**RE: APPROVAL OF CLASS I MODIFICATION OF SAFETY-KLEEN HAZARDOUS
WASTE PERMIT
SAFETY-KLEEN – FARMINGTON NMD980698849
TASK # HRMB-SKFA-99-001**

SAFETY-KLEEN FARMINGTON, NM FACILITY
HAZARDOUS WASTE PERMIT

PROPOSED PERMIT MODIFICATION

BARREL WASHER / REUSE SOLVENT SUPPLY TANK PIPING ISOMETRIC

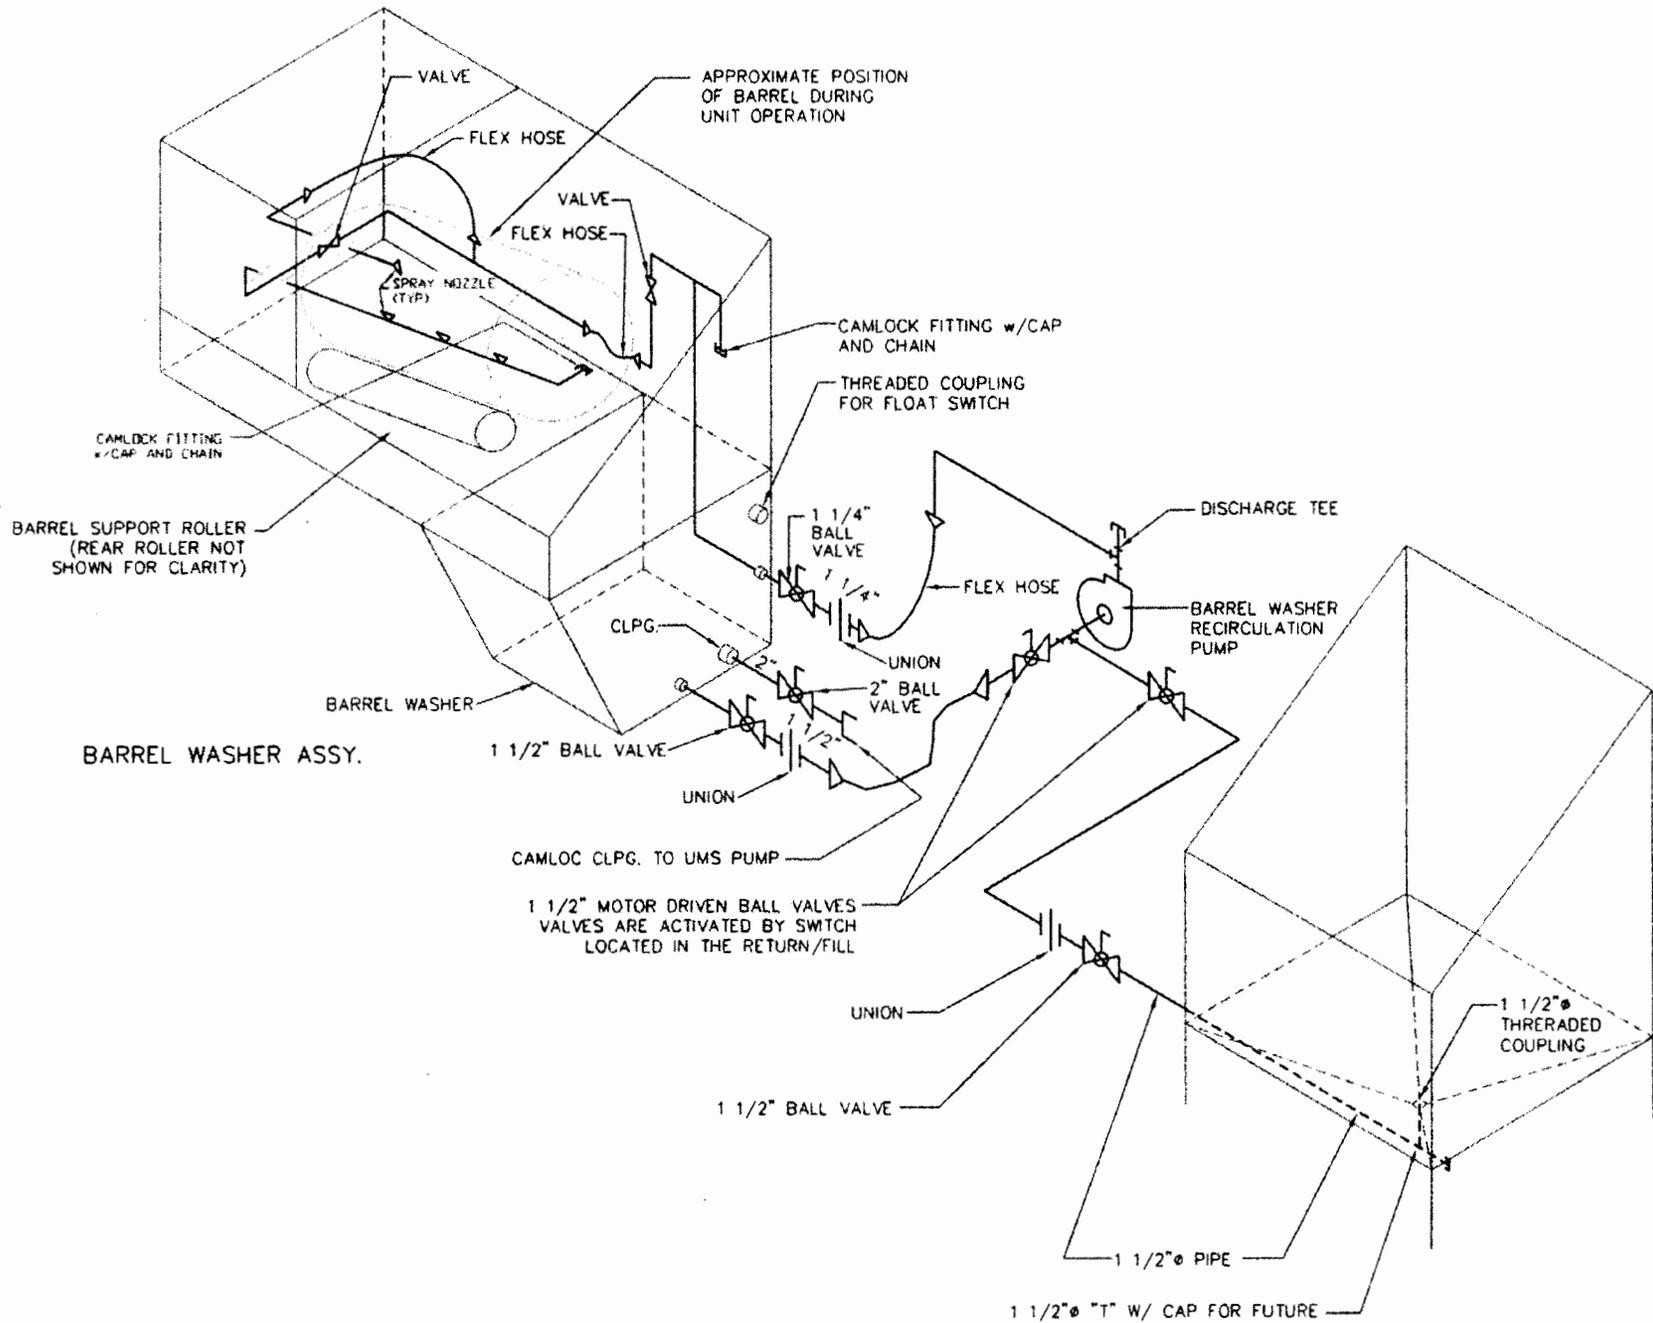
The New Mexico Environment Department (NMED) Hazardous and Radioactive Materials Bureau (HRMB) has completed review of Safety-Kleen's request for Class I Permit Modification of the current operating Permit. Your Permit Modification request of December 2, 1999, defines "Continued Use Solvent" as used parts washing solvent which still retains the capacity for less rigorous cleaning applications. The permit modification requests upgrading the drum washer/wet dumpster system at the return that preferentially uses "Continued Use Solvent" from an adjacent 200-gallon tank. When "Continued Use Solvent" is not available, the upgraded drum washer would complete drum cleaning with recirculated solvent.

Based upon the information which Safety-Kleen, Farmington has supplied to HRMB, NMED hereby approves the Class 1 Permit Modification for Safety-Kleen, Farmington. The effective date of approval is the date you receive this letter. The proposed changes are shown in Attachment A of this letter. The approved changes are in Attachments B and C of this letter. These changes have been incorporated into the Safety-Kleen, Farmington Hazardous Waste Permit EPA ID #: NMD980698849. You are required to incorporate the enclosed copy of Attachment B to page 1 of Module IV of the operating Permit formerly issued by NMED. You are also required to incorporate the enclosed Attachment C to the facility drawings in Attachment E of the Permit previously issued by NMED.

Ancillary equipment to the waste solvent tank includes a return and fill station containing an enclosed metal cabinet which serves as a sump into which the contents of a drum of used solvent can be emptied. A maximum volume of 40 gallons is retained in the sump of the metal cabinet. A float switch controls a pump that moves excess solvent to the spent solvent tank. The metal cabinet also contains a jet, which cleans the sediment from the drum. An additional 200-gallon metal tank containing used parts washing solvent still retaining the capacity for less rigorous cleaning applications is connected to the metal cabinet. This tank is the primary source of solvent for drum washing. When this tank is empty, solvent residing in the bottom of the main cabinet is recirculated through the drum washer for any remaining drum cleaning requirements. All spent solvents and sediments are then pumped into the spent solvent tank. The return and fill station has a roof and is equipped with concrete secondary containment with a capacity of 648 gallons. Piping to the tank from the return and fill station is steel, with welded joints. It is protected by secondary containment except for about five feet at the rear of the return and fill station (which must be inspected daily for leaks). The pump, which provides clean solvent for

filling drums, is located within the secondary containment for the tanks, and all its associated piping is located within secondary containment. The connections for emptying the spent solvent tank and filling the clean solvent tank (from tanker trucks) are located within the secondary containment.
